RE: **Replacement Well Issues**
Route 97
Well Permit # HO-94-3549

STATE OF MARYLAND
APPLICATION FOR PERMIT TO DRILL WELL
517984 please type low yield

SITE INSPECTION SHEET

LOCATION DIAGRAM

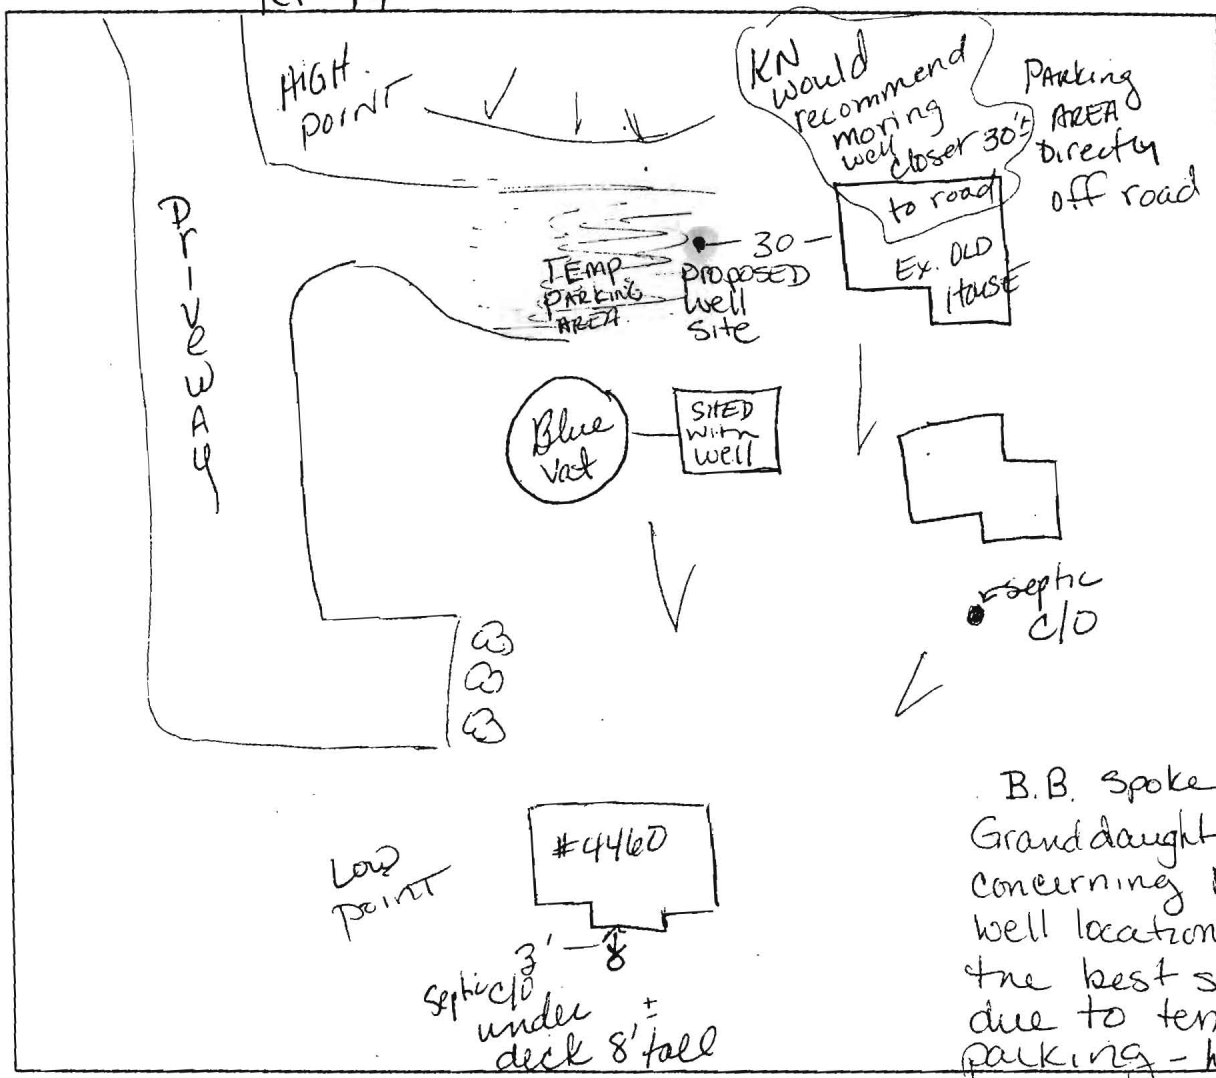
SPECIAL CONDITIONS
NOTE: APPROVING AUTHORITIES SHOULD USE SEPARATE SHEET IF NEEDED

OPTIONS: DRILL WELL AT LOCATION PLACING AN ACCEPTABLE BARRIER AROUND ITS SIDES
 MOVE 30'± CLOSER TO ^{OR} ROAD FROM PROPOSED LOCATION

B.B. spoke to Granddaughter concerning proposed well location not in the best spot due to temporary parking - but a crack casing

COMMENTS: 10/29/02 There are two houses on this one lot. Currently, daughter lives in house closest to road and "Grandpa" lives down the hill. One well currently serves both homes. Permit App says
